7 MR. McKELVEY: My name is Terry McKelvey. I am
8 the principal electrical engineer involved in the design of
9 Fermi 2. And I am going to present to you the reliability
10 of our station power, including the effects of the loss of
11 various stages of AC and DC, and get into the discussion on
12 station blackout.

16 Also for its independence and how we derive it
17 from our electrical transmission system. First of all, the
18 offsite power source at Fermi 2 is made up of five separate
19 transmission lines, two from our 345-kV system and three
20 separate lines on the 120-kV.

FIG 1 ENRICO FERMİ 2 OFFSITE POWER SOURCES

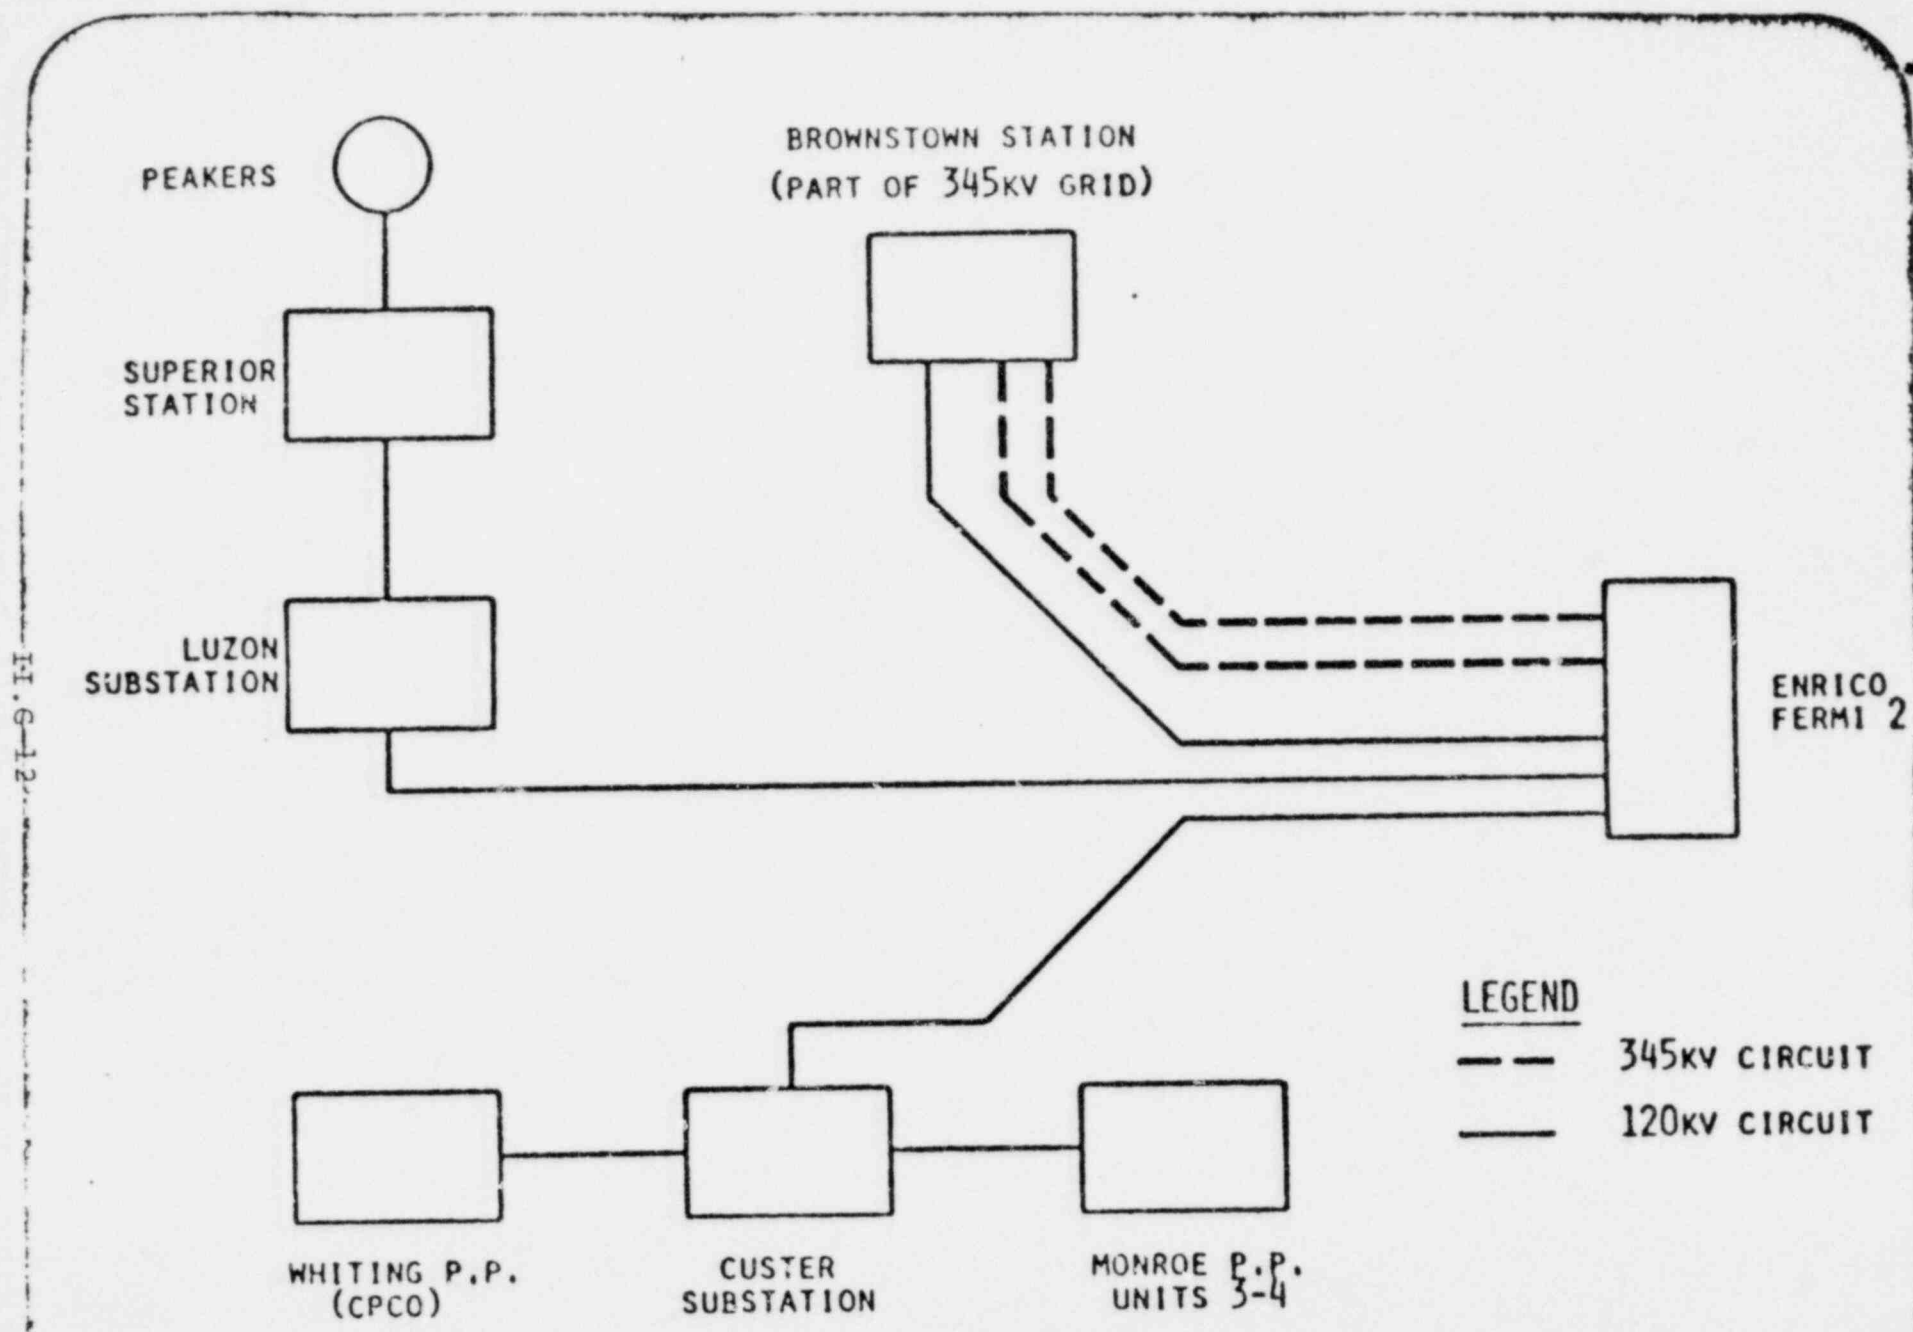
4 MR. CARBON: How widely separated are the five
5 lines coming into the plant?

18 MR. RAY: When you say they are designed -- the
19 falling tower will not impact an adjacent line?

2 MR. RAY: You have not answered the question, but
3 you have given me an implied answer. I gather from what you
4 say that if the EHF line went down it would take down one of
5 the 120-kV lines, is that what you are saying?

11 MR. RAY: All five lines are on the same right of
12 way?

17 MR. RAY: Are you saying, then, that if one of the
18 345-kV lines failed it would take out three 12-kV lines with
19 it? It would take out three 120's? So a falling tower on
20 the high line could leave you with one line.

23 MR. RAY: Is the system stable under these
24 conditions?

6 MR. McKELVEY: Okay. There is a common
7 transmission corridor into Fermi 2 for approximately five
8 miles. That is as shown here (Indicating). The line -- the
9 corridor is 500 feet wide. It has been designed to take the
10 worst failure of any structure falling over that would leave
11 enough lines -- all we need out of these five lines is one
12 separate line existing to power adequate ESF at Fermi 2.

13 So we have designed the spacing of the
14 transmission lines on this common corridor to accommodate
15 the falling over of a 345-kV tower.

20 MR. McKELVEY: There are five separate lines. The
21 345-kV towers are on the outside of the 500-foot right of
22 way. In the center are the three 120kV lines. Obviously,
23 the largest structure is the 345-kV tower and if one of
24 those lines fell over across the other transmission lines we
25 would still have adequate transmission lines available to

8 MR. McKELVEY: It might take a couple lines down.
9 We would have at least one transmission line available to
10 the site.

21 MR. McKELVEY: That is right, in the worst
22 scenario.

25 MR. McKELVEY: Yes. The system has been analyzed

FIG. 2 ENRICO FERMI 1 120KV SWITCHYARD

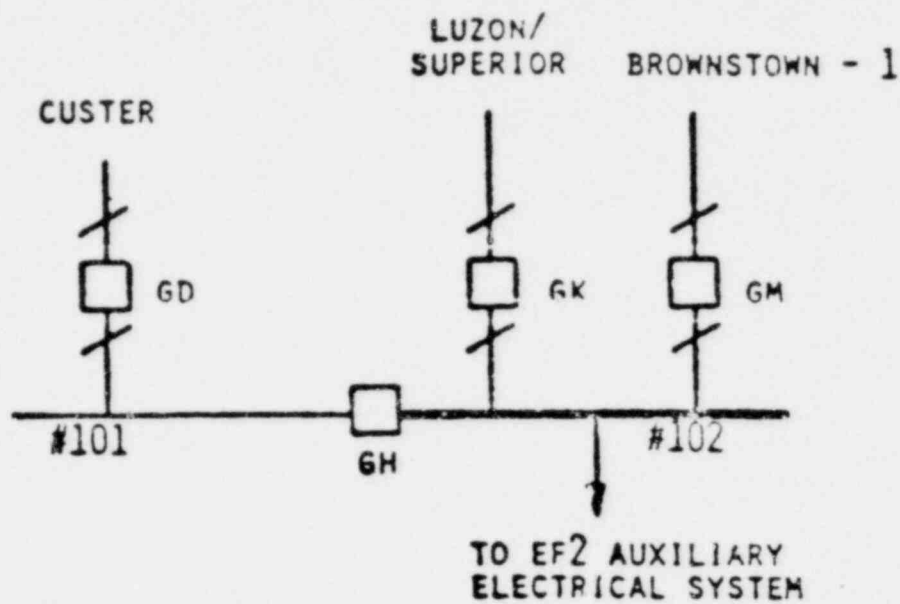
18 MR. RAY: Is that bottom feed to the right that
19 goes downward -- I cannot read it. The 120-kV, is that the
20 point of connection of these other units that are on the
21 Fermi site?

22 MR. McKELVEY: Right. The next slide will show
23 that. Note that this is bus 102.

8 MR. McKELVEY: It was tied to the other bus, bus
9 101 in my previous slide.

FIG. 15 ENRICO FERMI 2 260/130VDC DISTRIBUTION SYSTEM

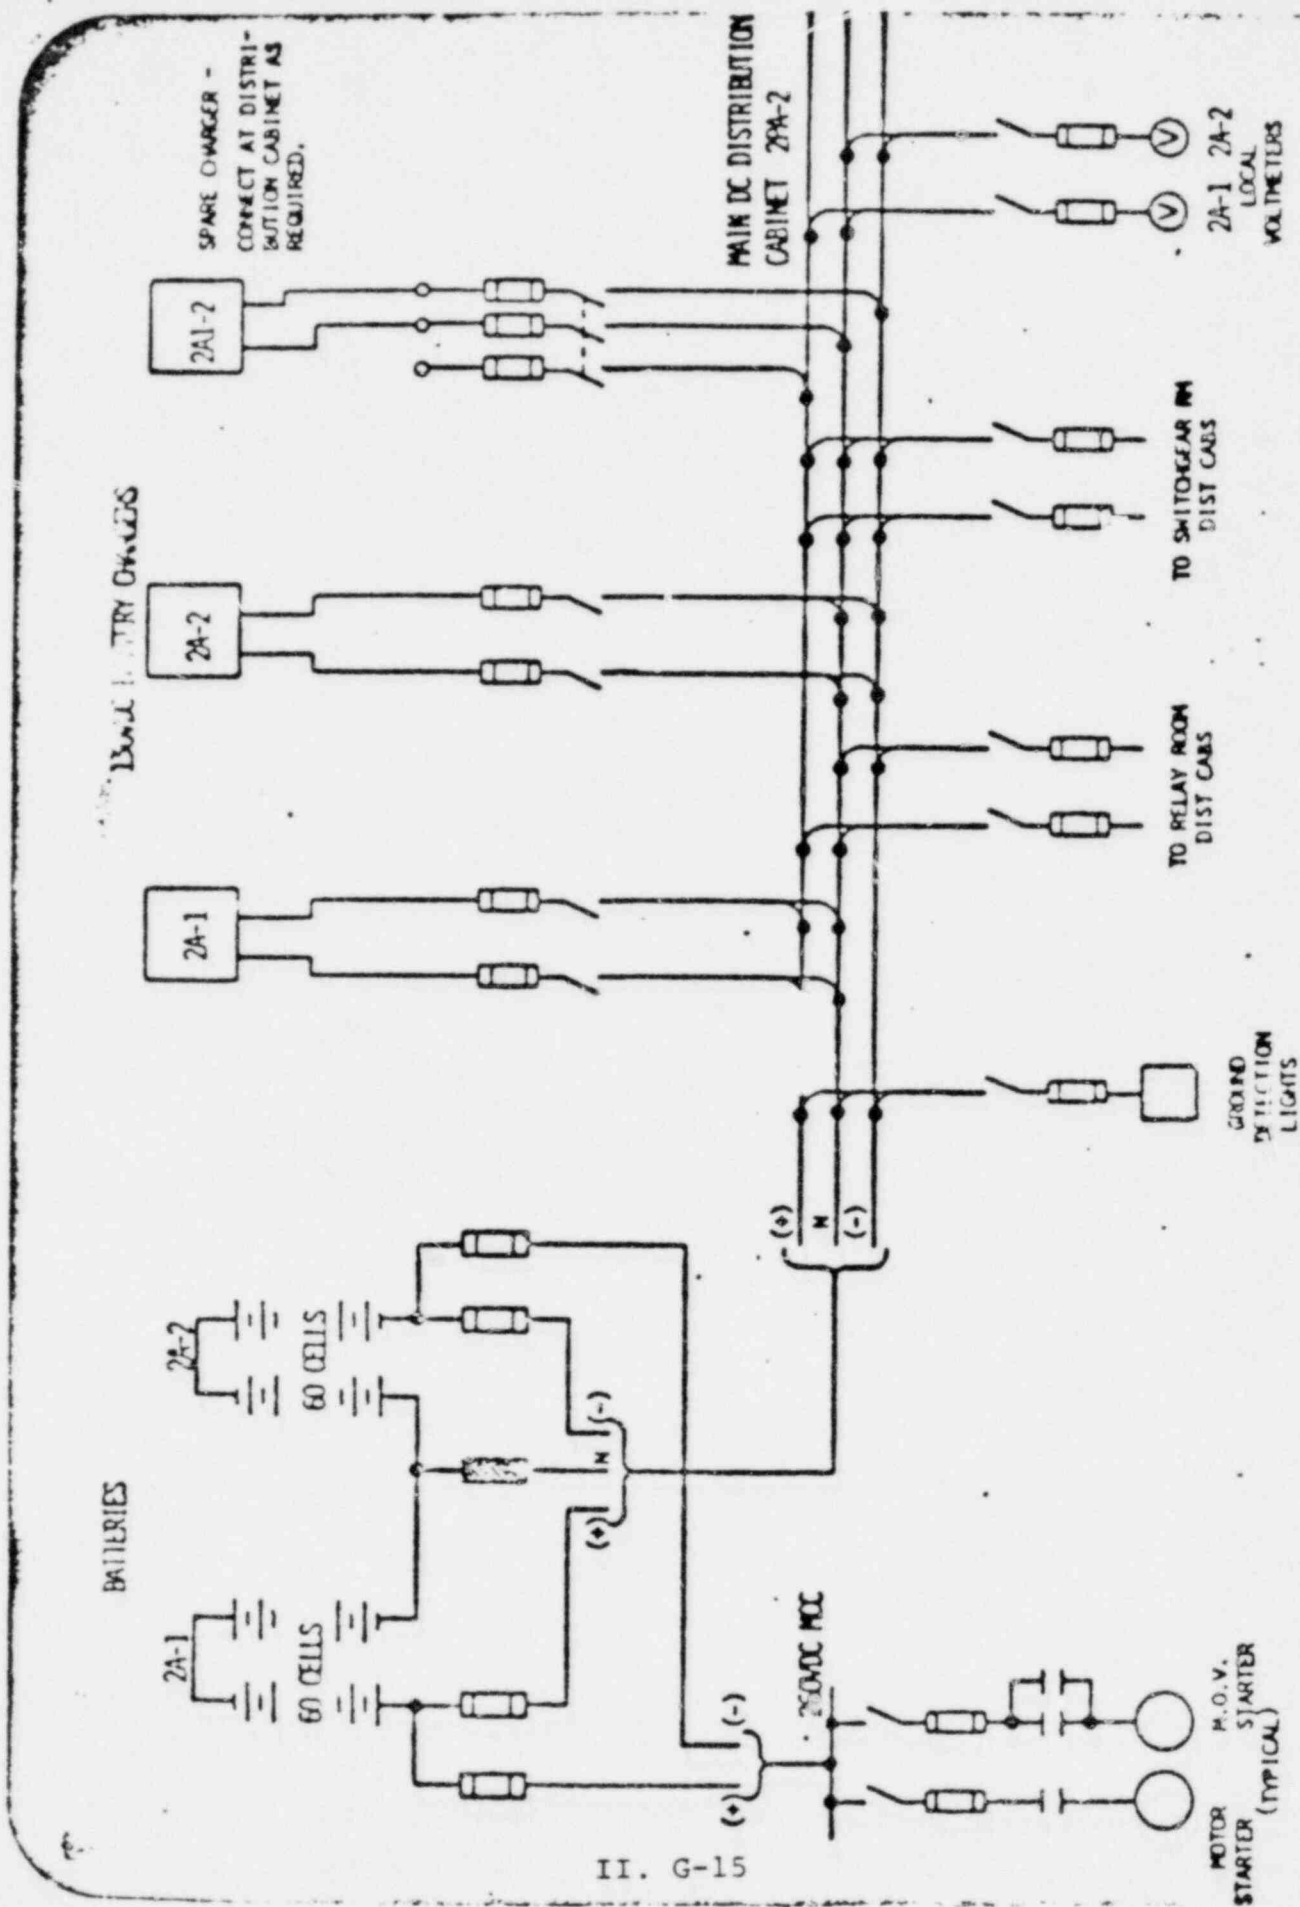
4 MR. ZUDANS: Can I ask a quick -- if you would not
5 have batteries, just a charger by itself, could you use it?

10 MR. RAY: A quickie. You said should you lose one
11 division DC supply -- maybe I am interpreting this too
12 broadly -- you could back up those loads from the other
13 division.

15 MR. RAY: This says you have ties between the two
16 divisions.

6 MR. McKELVEY: Definitely.

8 MR. McKELVEY: The chargers have their own
9 automatic voltage regulation.

17 MR. McKELVEY: No, not the same loads. Redundant
18 loads.

21 MR. McKELVEY: No, they are fully independent.
